CRANBERRY LAKE BOAT LAUNCH PROPOSED FINAL AMENDMENT

1996 Cranberry Lake Boat Launch Unit Management Plan
St. Lawrence County

UMP AMENDMENT #1

This proposed amendment to the Cranberry Lake BLS UMP is for the construction of an accessible beach launch for hand-carry boats, including canoes and kayaks. The construction will include two accessible parking spaces with an associated access aisle located next to an accessible port-a-John. This will also include a 5-foot wide accessible path connecting the parking area, the port-a-John, and the beach launch areas. In addition, two accessible parking spaces for vehicles with

Figure 3. Orthoimagery map of the existing Cranberry Lake BLS with site plan details.

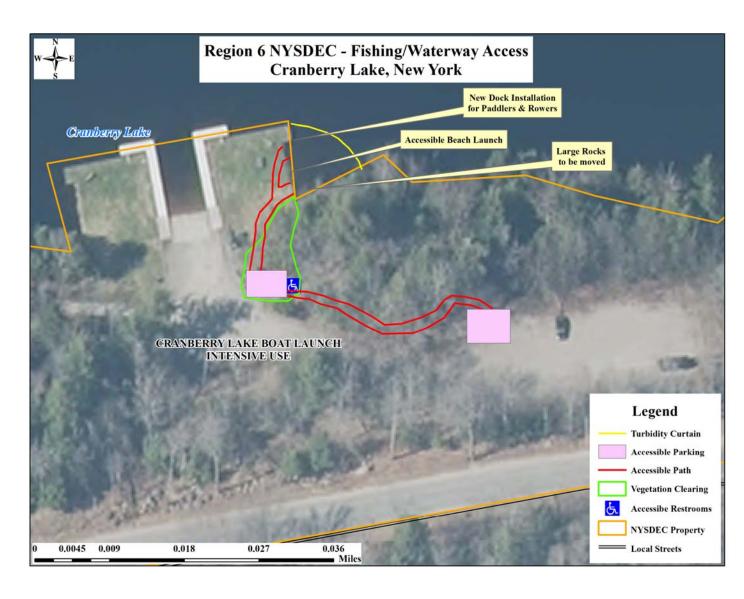
- 4. Develop two (2) accessible parking spaces with an associated access aisle in the parking lot (see Figure 3) to be compliant with accessibility guidelines to the position depicted in the site plan drawings.

- 5. Develop two (2) accessible parking spaces for vehicles <u>with trailers</u> and an associated access aisle near the lower parking lot (see Figure 3) to be compliant with accessibility guidelines to the position depicted in the site plan drawings.
